**NEBRASKA ARMY NATIONAL GUARD
NORFOLK FMS #7 SUSTAINMENT**

PROJECT NO. 31100088

A D D E N D U M N O . 1

ADD 1-1 Replace Drawing Sheet A-8 (attached PDF):

SHEET:
A-8
 8 OF 8

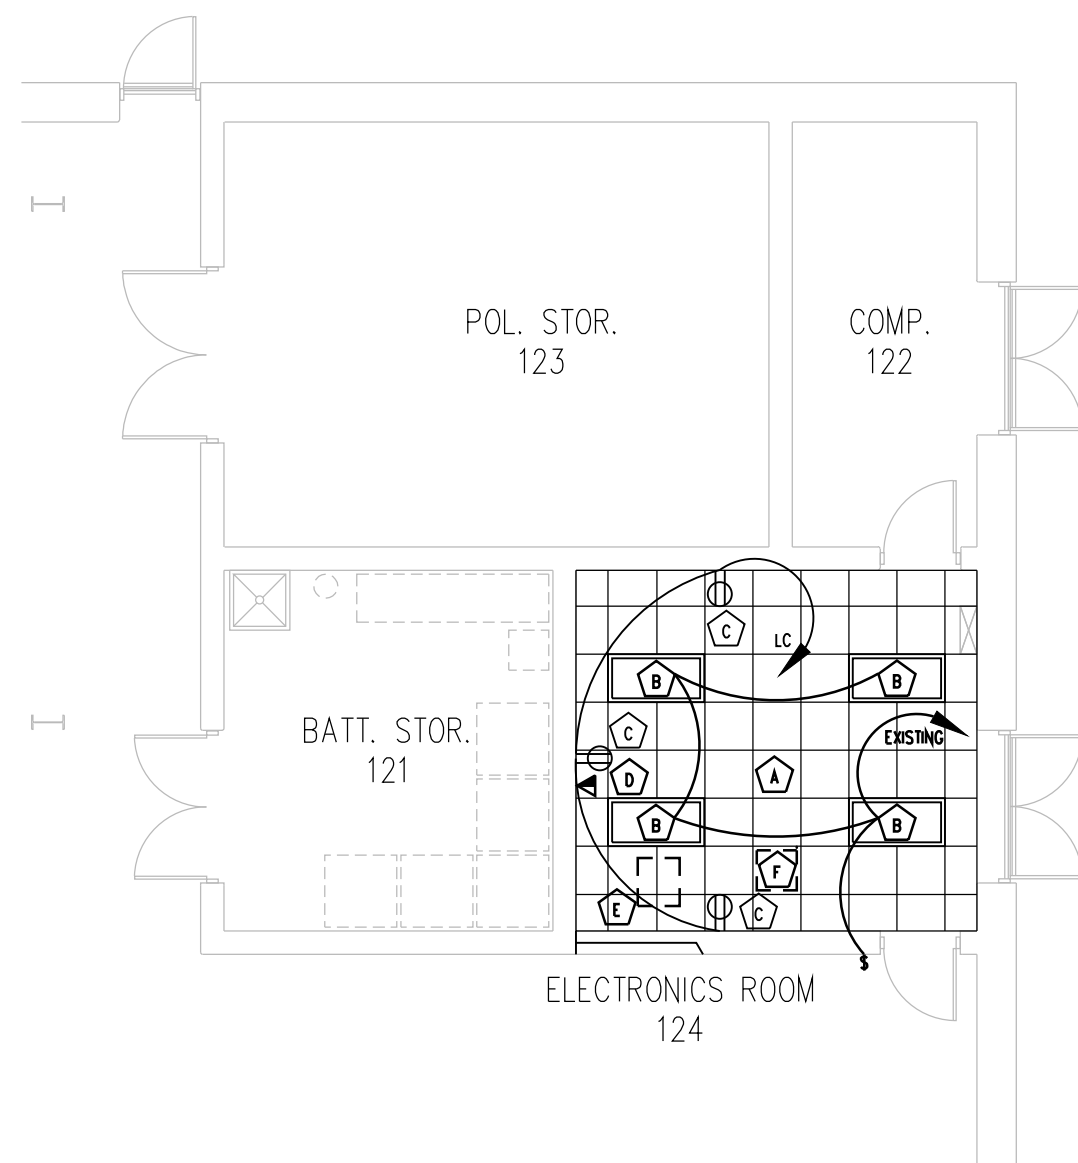
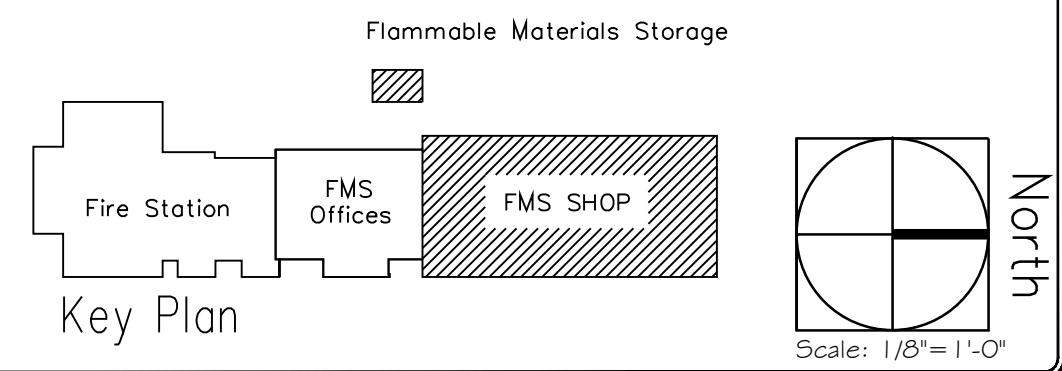
The existing wall mounted heater in Electronics Room "shall be removed." Install a new heater recessed in the ceiling. Heater shall be QMark CDF-558 with CDF-T4 thermostat or equal. Upgrade circuit breaker to 30 AMPS as required by heater specs..

- E. Heater**
1. Remove existing wall mounted heater.

- E. Heater**
1. Install new heater recessed in ceiling.
 2. Heater shall be QMark CDF-558 with CDF-T4 thermostat or equal.
 3. Upgrade circuit breaker to 30 AMPS as required by heater specs.
